Salboy
Back Turner Street
External Materials + Planning Updates

Proposed changes to Non Material Amendment Approved Application

The purpose of this report is to document the proposed design amendments to the Back Turner St - original planning approval Reference 126638/FO/2020 26.06.20, subsequently updated with the approved NMA Application Reference: 128851/MMC/2020

2.1 Elevation Comparison Shudehill Block A

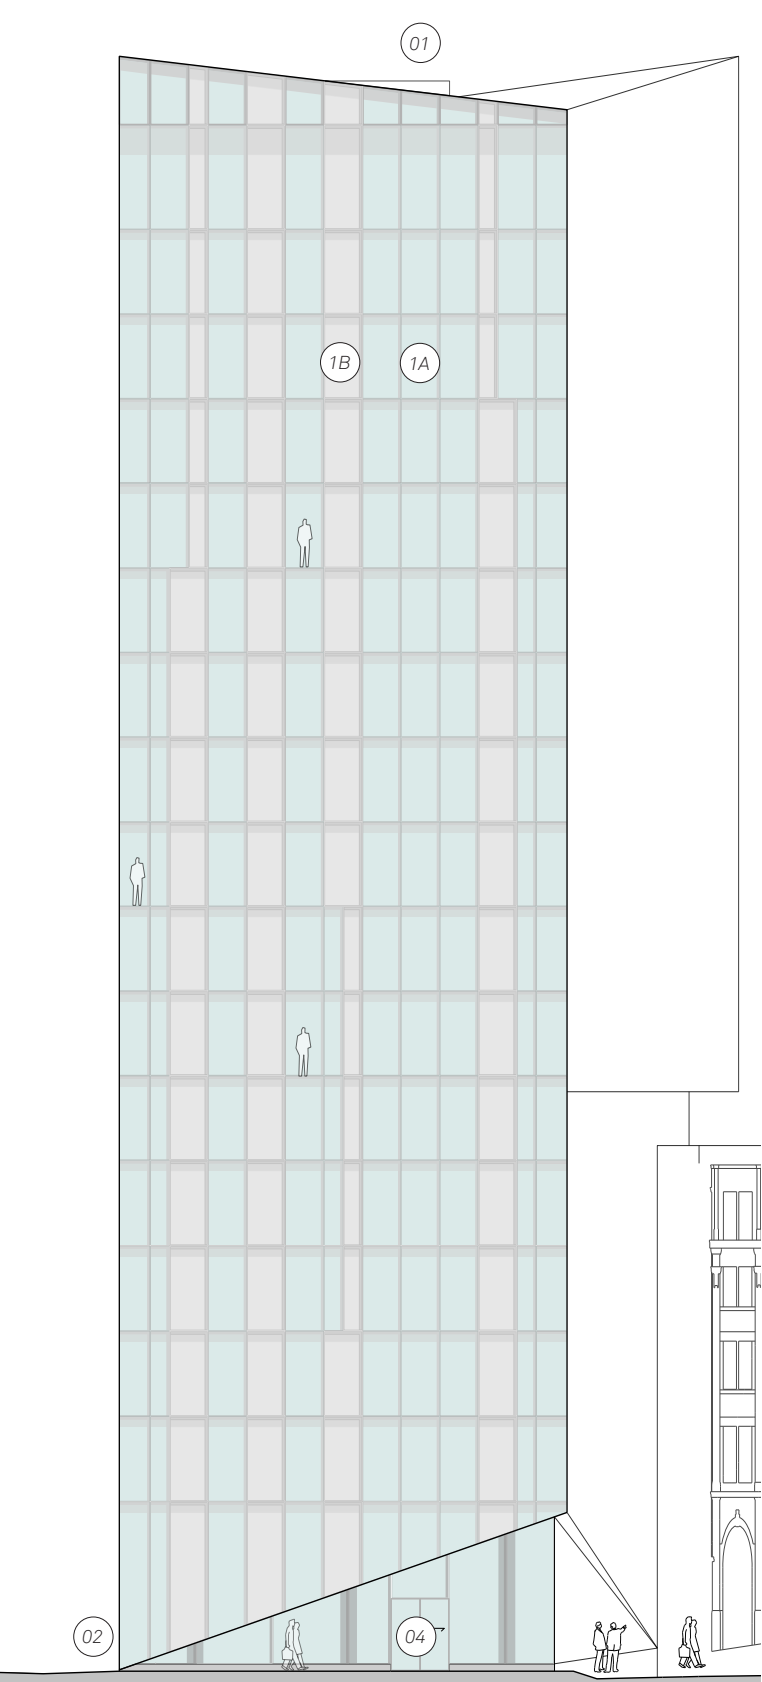
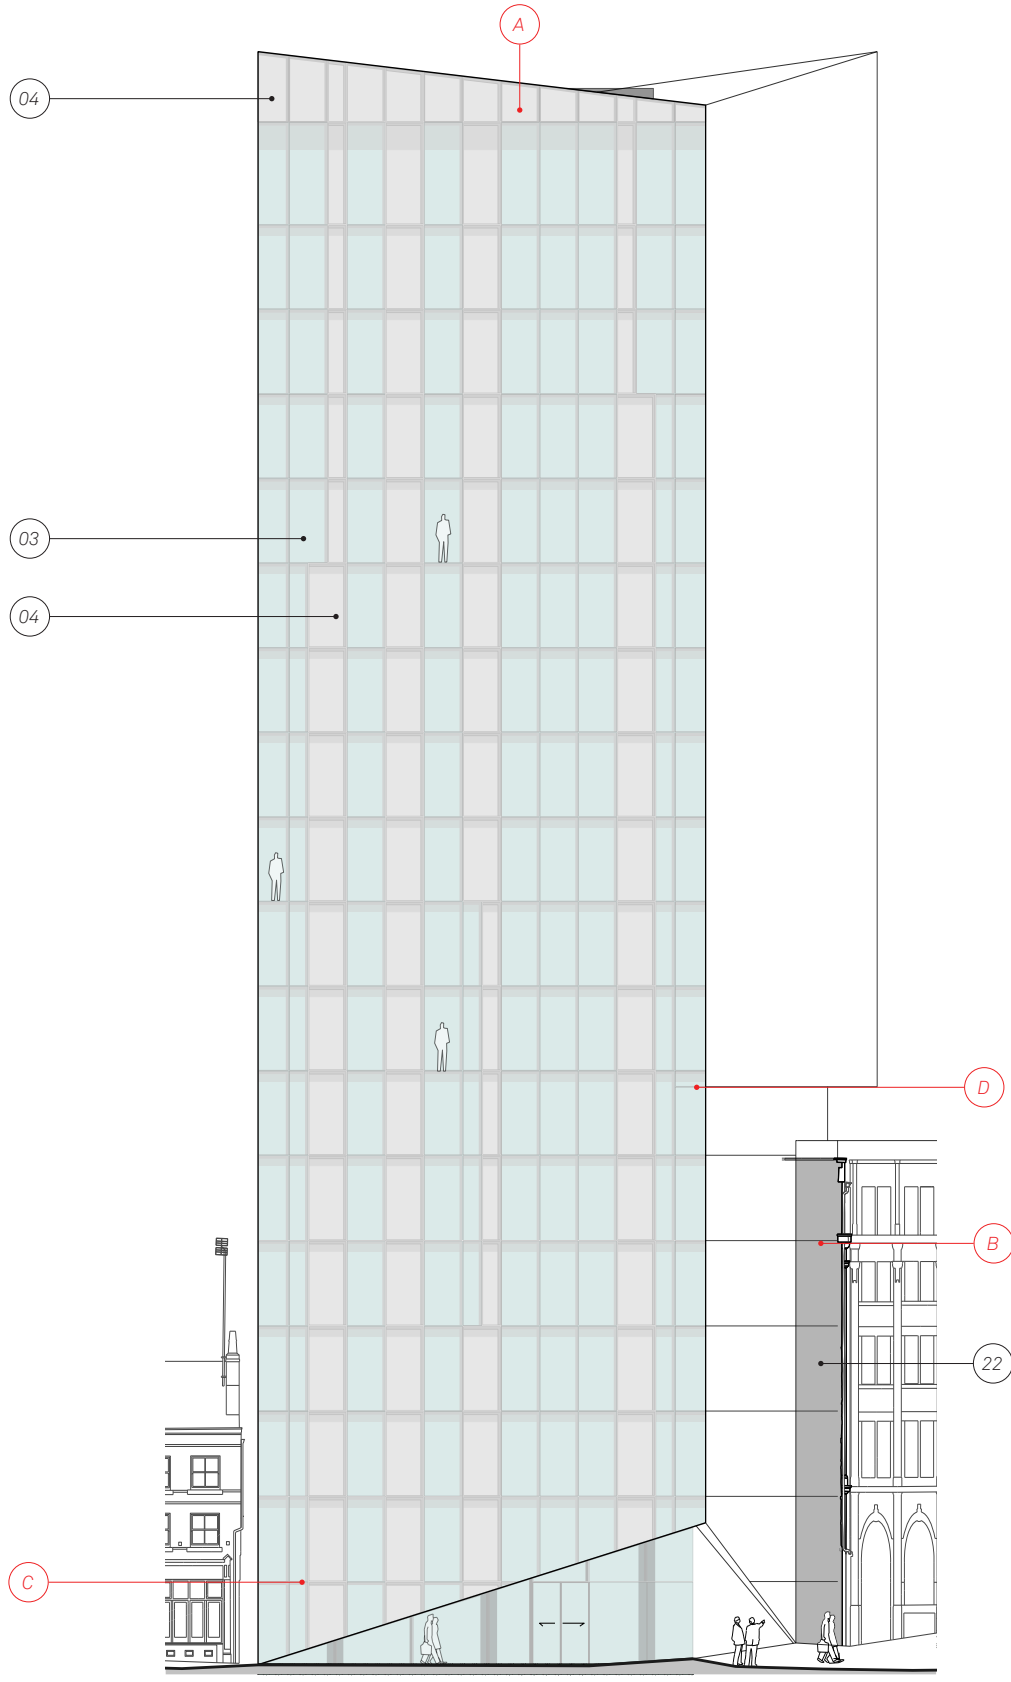
- **obscured glazing to the crown of the building to mask plant**
- **additional transom added to ground floor to mitigate oversized glazing**
- **metal infill to replace unsafe brickwork and render. The metallic grey cladding will act as a negative joint between the old and new.**

- A - Glazing to roof overrun to be 30% translucent
B - Due to the structural integrity of the stone wall elements, the return wall elements had to be demolished. It is proposed to replace this with a metal panel to distinguish the new build against the existing stone/brick facade
C - Additional transom. Glass size too large - See Technical Note.
D - Additional Unitised System Joint required (internal transom) to form corner soffit and change of angle in the facade at Back Turner Street at level 6

2.2 Elevation Comparison Back Turner Street Block A

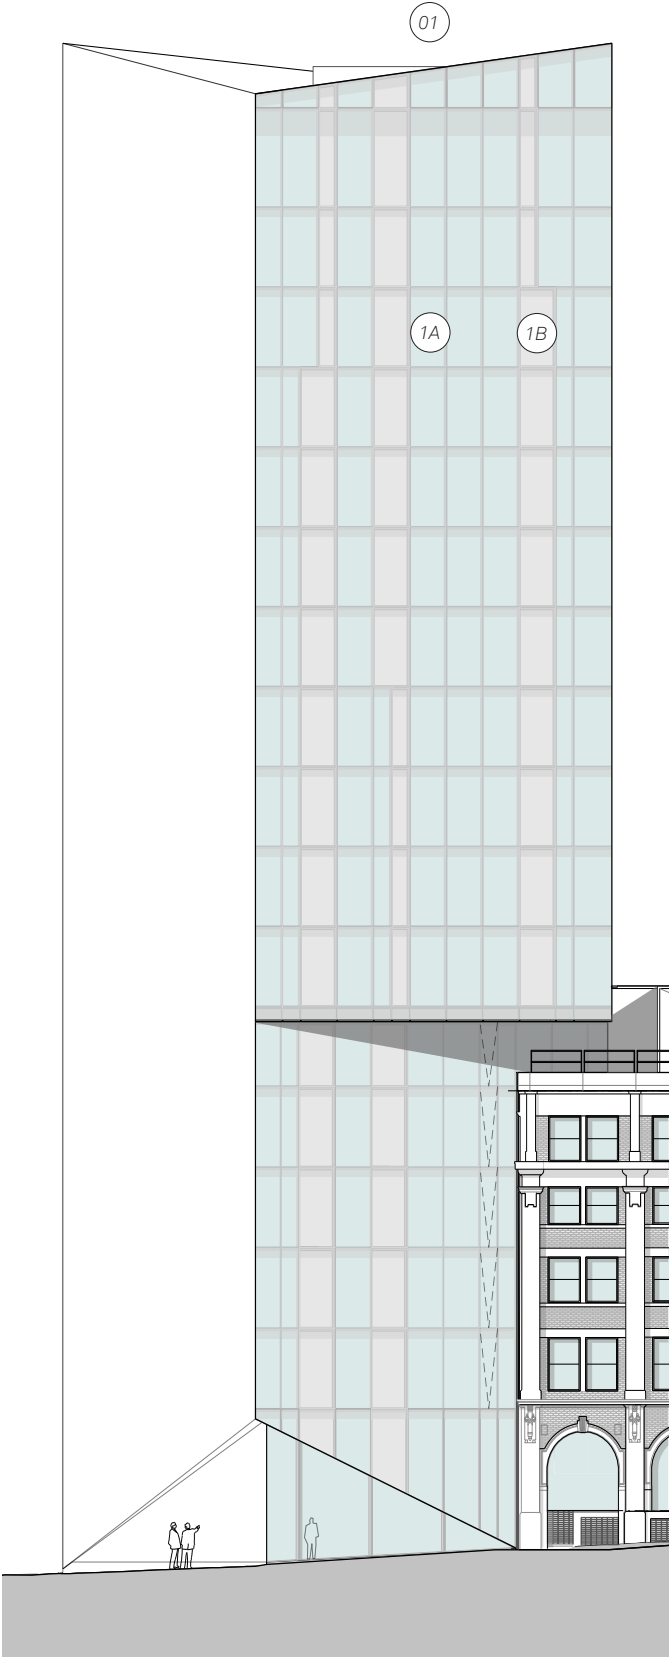
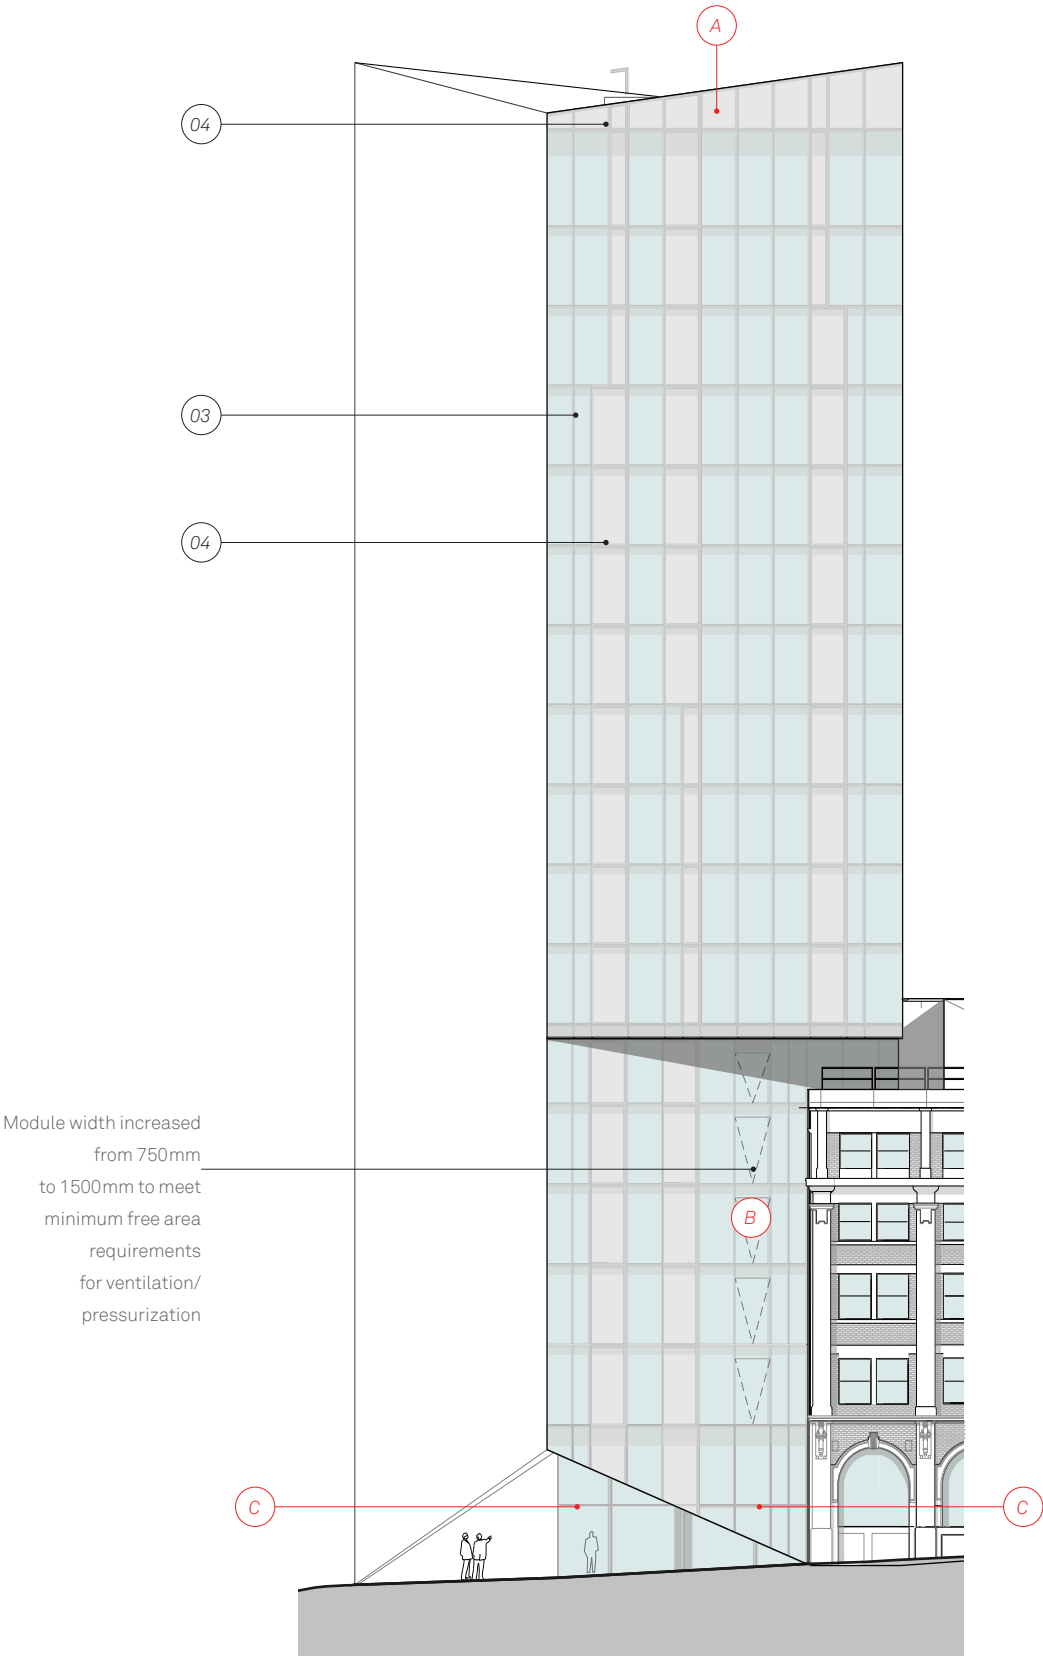
- Summary of changes proposed
- obscured glazing to the crown of the building to mask plant
 - AOV added to meet fire requirements to lower floors 1-4.

- A - Glazing to roof overrun to be 30% translucent
B - AOV relocated to provide minimum free area for smoke systems
C - Additional transom. Glass size too large - See Technical Note

2.3 Elevation Comparison High Street Block A

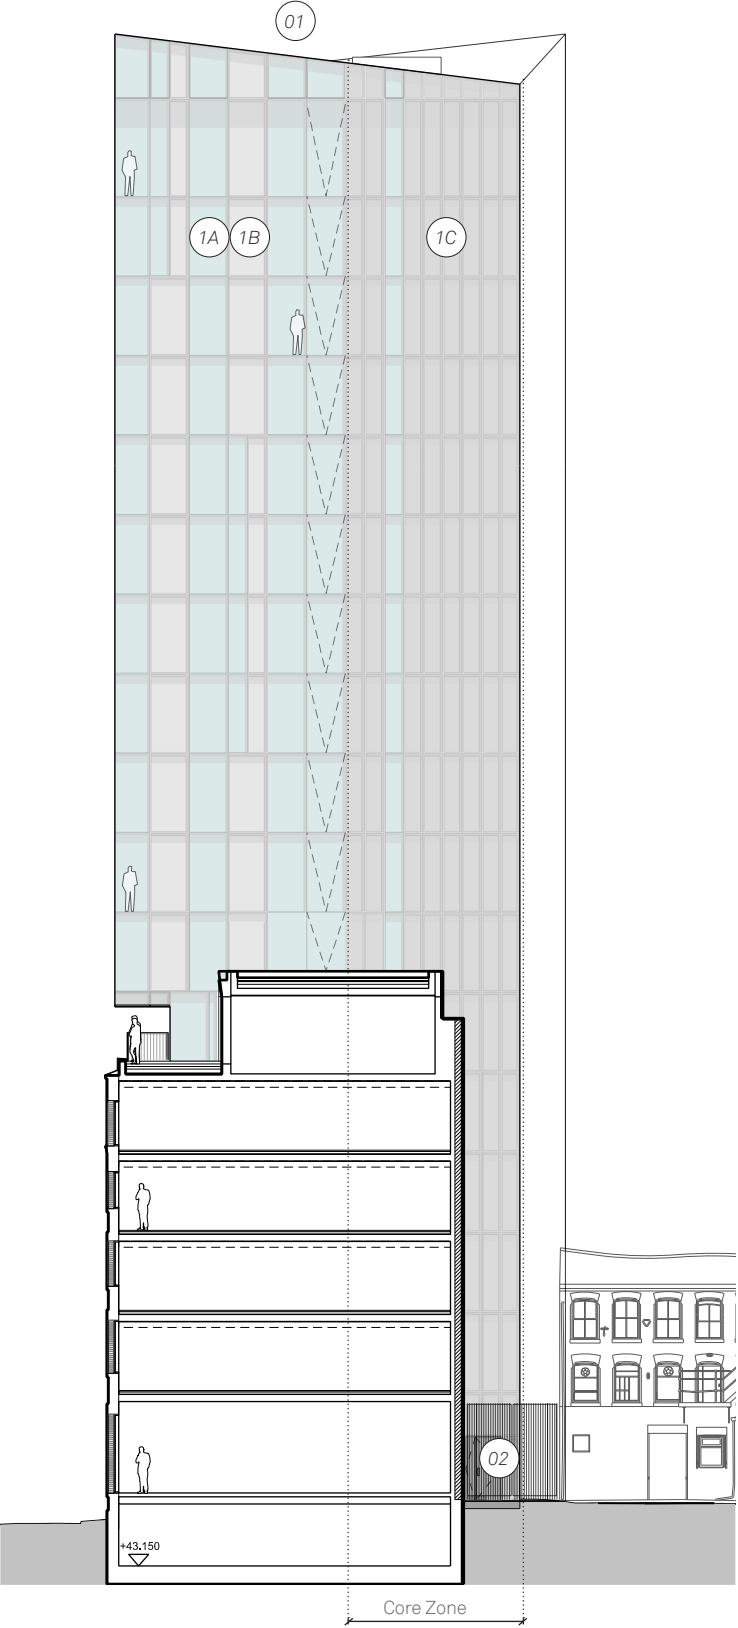
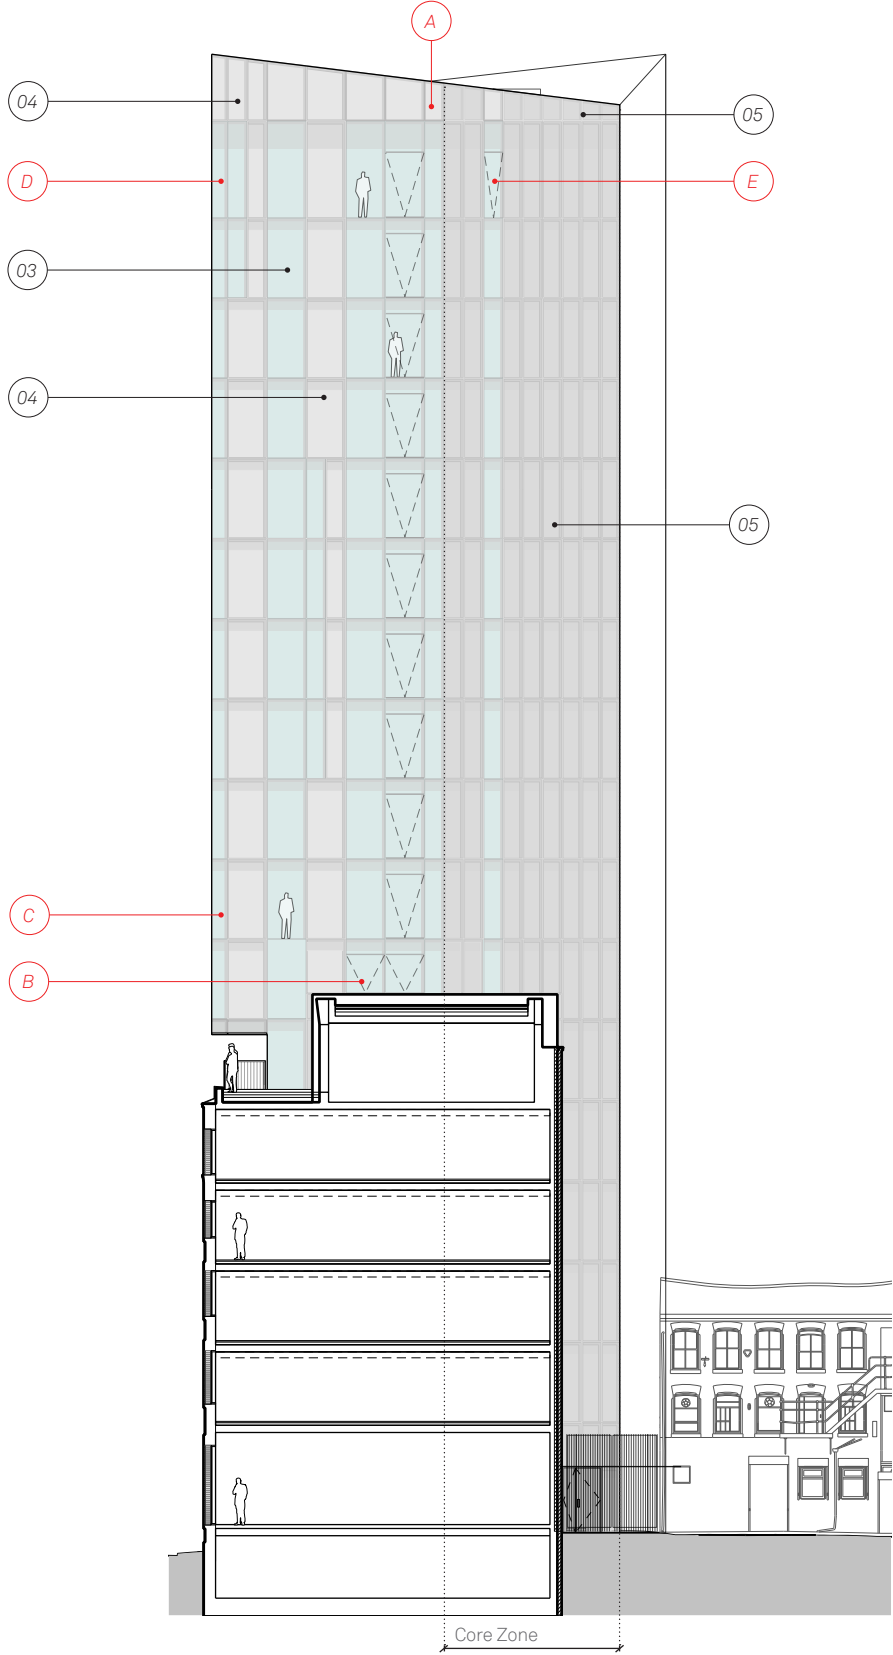
- Summary of changes proposed
- obscured glazing to the crown of the building to mask plant
 - additional AOV added to the tower to provide free area to 6th fl
 - tower glazing modules adjusted to allow for improved vertical alignment

- Planning Material change Key
- A - All glazing to roof overrun to be 30% translucent
 - B - Additional AOV
 - C - Glazing module amended
 - D - Additional mullion. Corner glass size too large - See Technical Note
 - E - Additional AOV added to stair core
